**OFFICIAL AGENDA
PLANNING & ZONING COMMISSION
CITY OF STARKVILLE, MISSISSIPPI
MEETING OF TUESDAY, October 10, 2023
1ST FLOOR CITY HALL – COURTROOM
110 WEST MAIN STREET AT 5:30 PM**

To: Members of the Planning & Zoning Commission
From: Daniel Havelin, City Planner (662-323-2525 ext. 3136)
Lyle McCaskey, Assistant City Planner (662-323-2525 ext. 3130)
Subject: Discussion and consideration of AA 23-01 a request for an Administrative Appeal of the decision of the City's independent consultant to deny approval of the building design proposal of Cadence Bank at 400 University Drive in a T-5C zoning district
Date: October 10, 2023

RE: Architectural Review – Cadence Bank

Project Name: Cadence Bank- Starkville Midtown Branch Bank

1 NORTH ELEVATION
SCALE 3/16" = 1'-0"

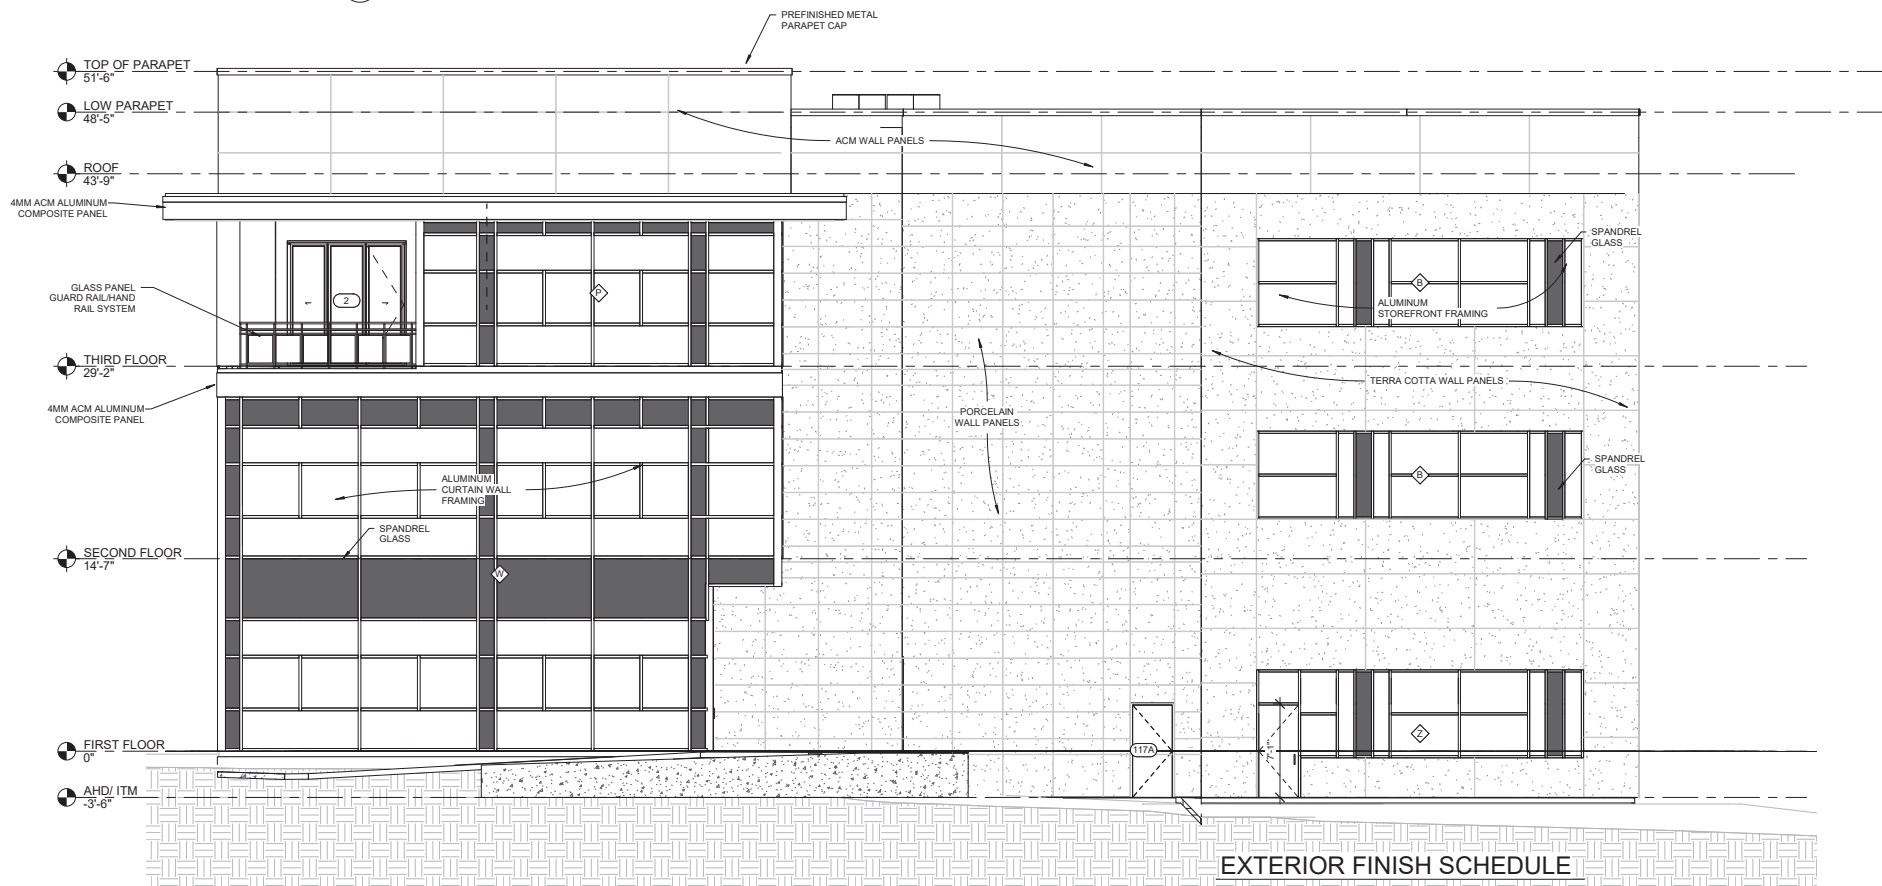
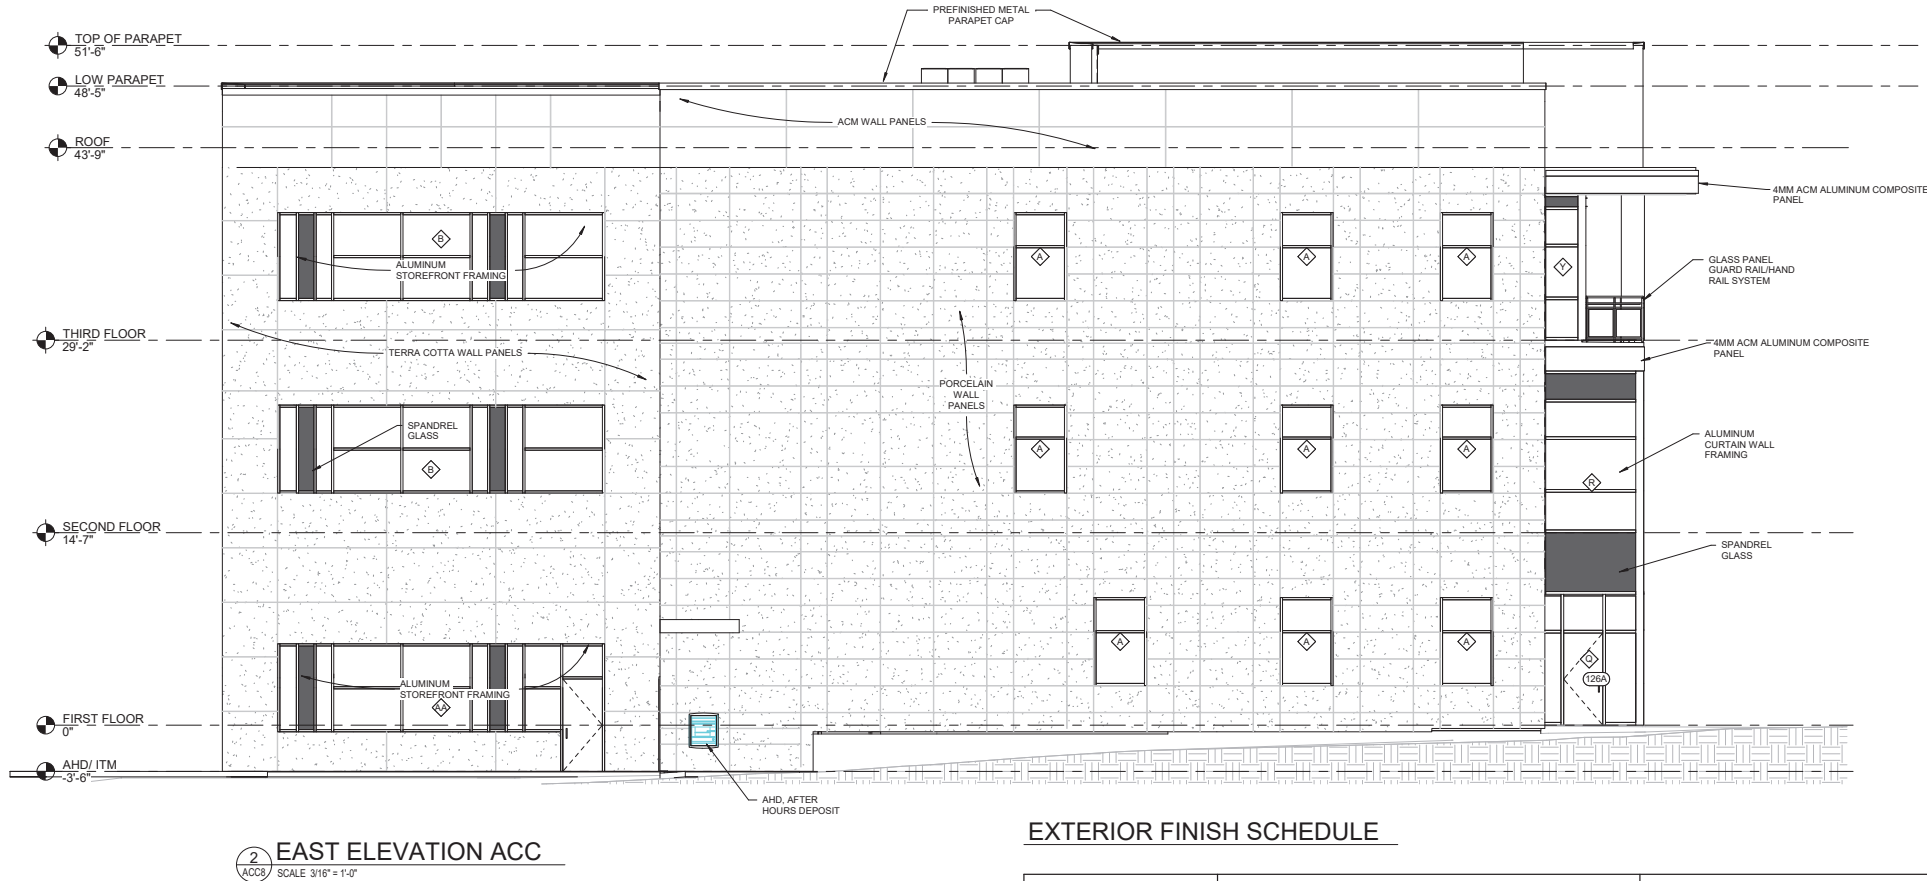
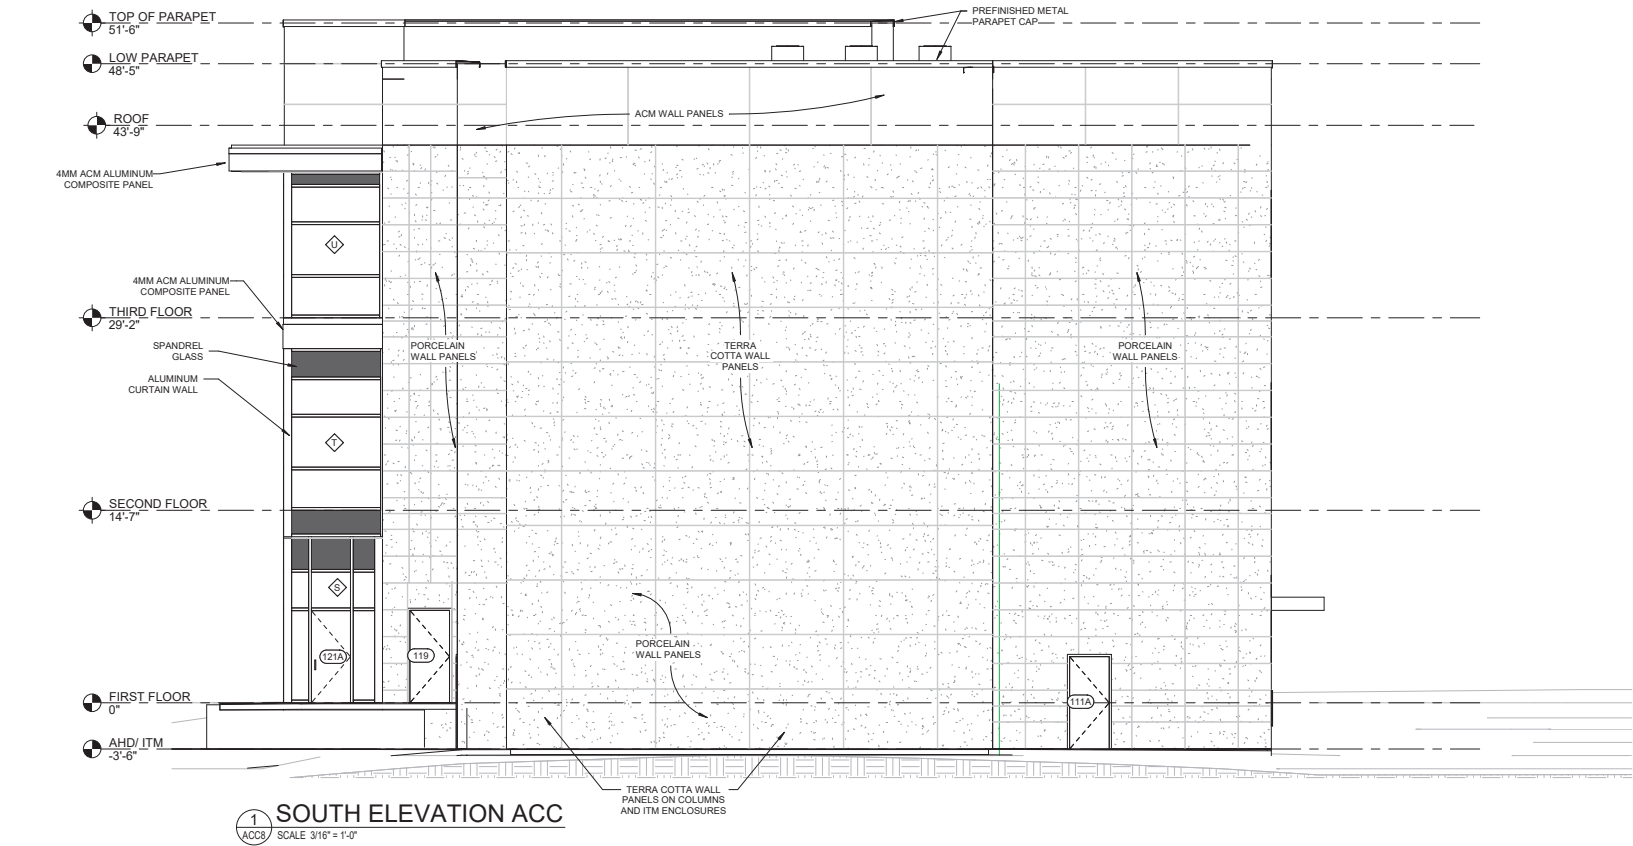
- 2. The entrance is a little difficult to detect from University Drive.**
- 3. Porcelain Wall Panels and ACM (Metal Panels) are not listed as approved materials. I find it difficult to interpret and had difficulty figuring out exactly what these panels are. An exact website address and a physical sample of material could be put under further review if the city would allow it.**

1. I do not see any site lighting on the site plan.
2. The entrance is a little difficult to detect from University Drive.
3. Porcelain Wall Panels and ACM (Metal Panels) are not listed as approved materials. I find it difficult to interpret and had difficulty figuring out exactly what these panels are. An exact website address and a physical sample of material could be put under further review if the city would allow it.
4. The dumpster is currently located within a setback. However, I feel like it is in the appropriate location on the site.

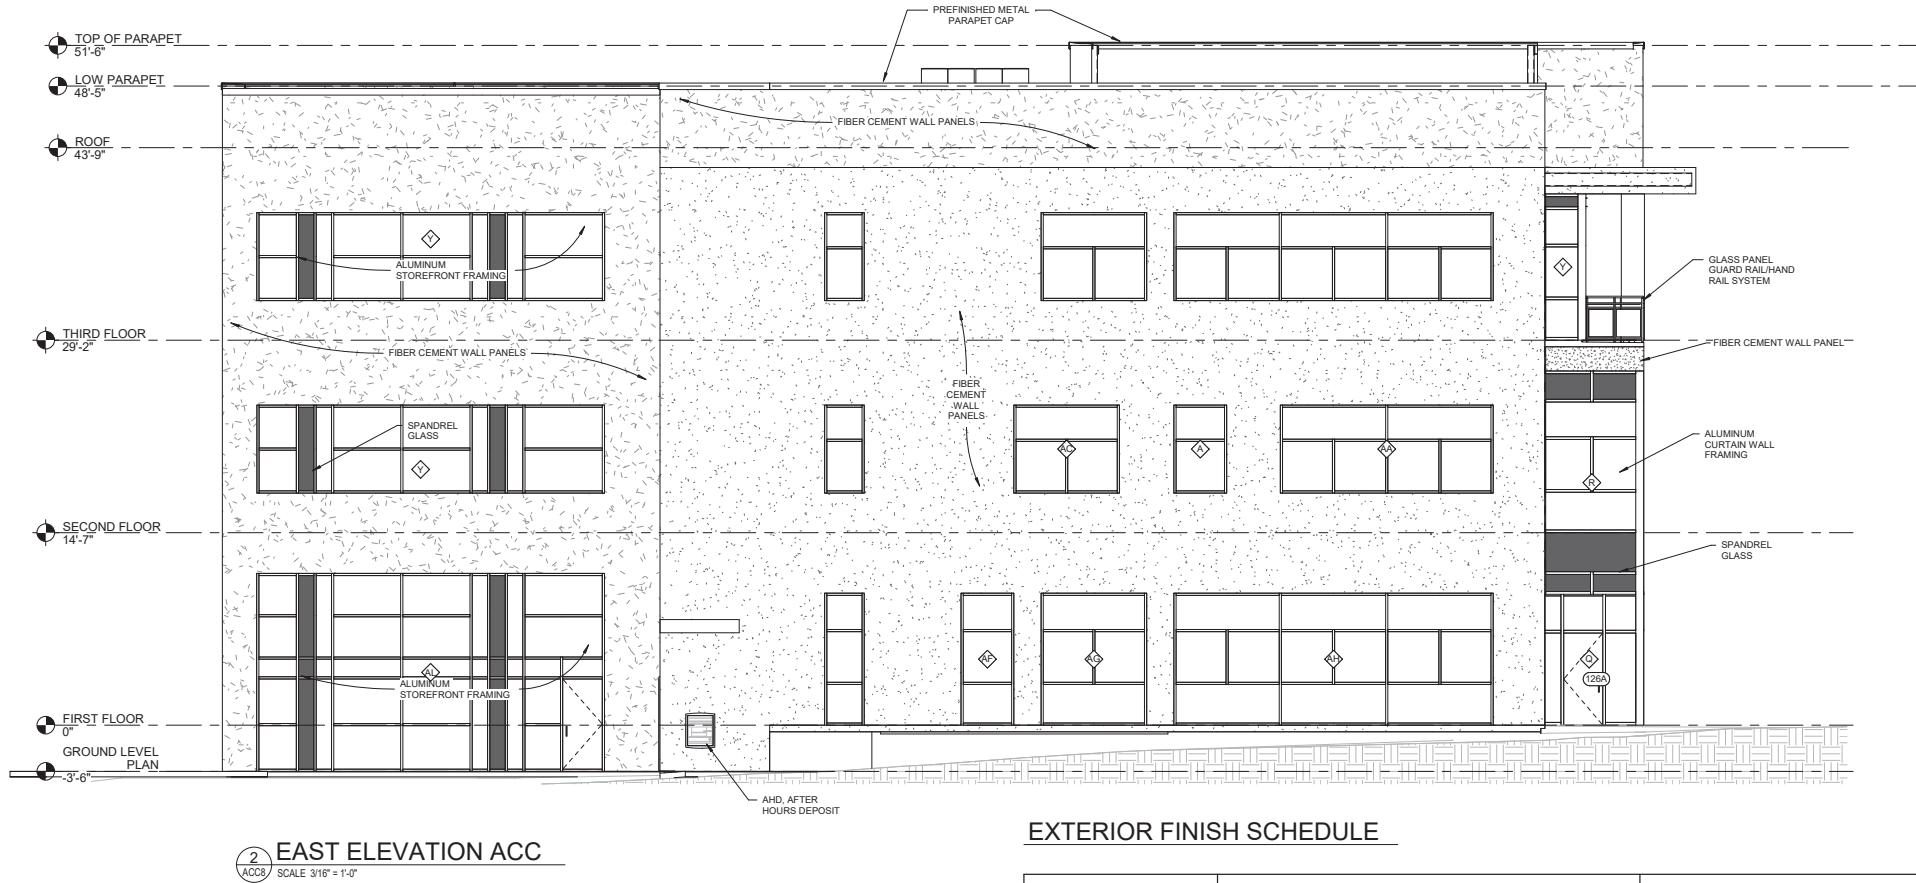
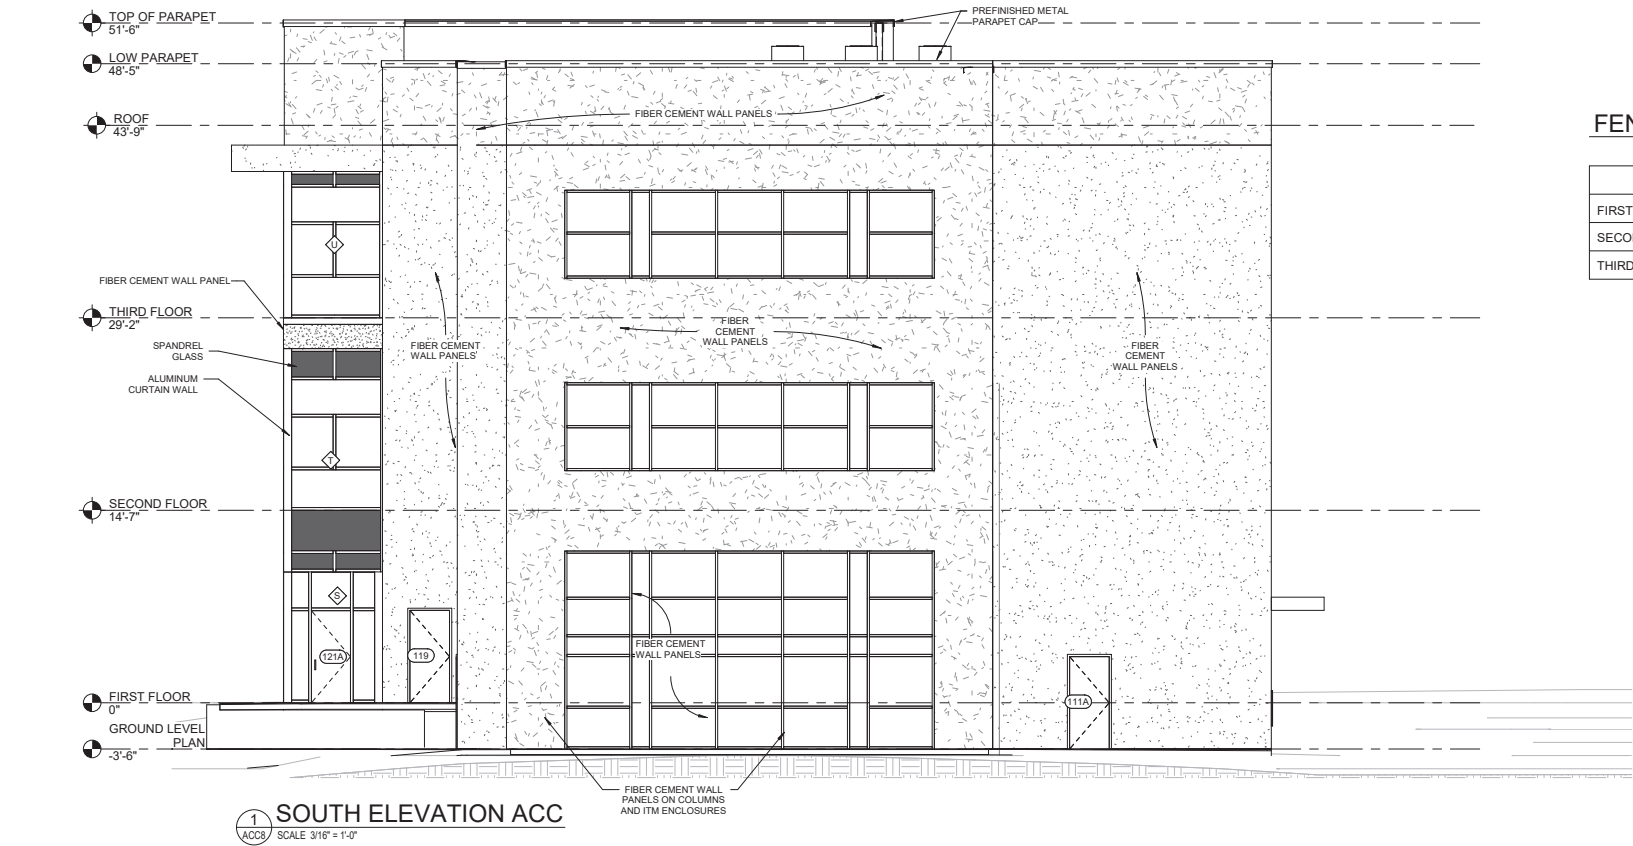
1. I do not see any site lighting on the site plan.
2. I am now questioning the idea of the contentious panel. Panels are not specifically called out in the list of materials. What will be the actual panel sizes and joint pattern?

This is a major corridor thoroughfare and contextually these panels do not fit the area. Brick would be a much more suitable material particularly given the magnitude of a bank. I am also questioning the choice of the white color. I feel like its reflectance will be over powering at this intersection. This area is meant to be the connection between downtown and the Cotton District that leads to the university. It should be building that holds its own but creates a connection to all of these things that happen in Starkville. This will be one of the most dominant corners in all of the city.
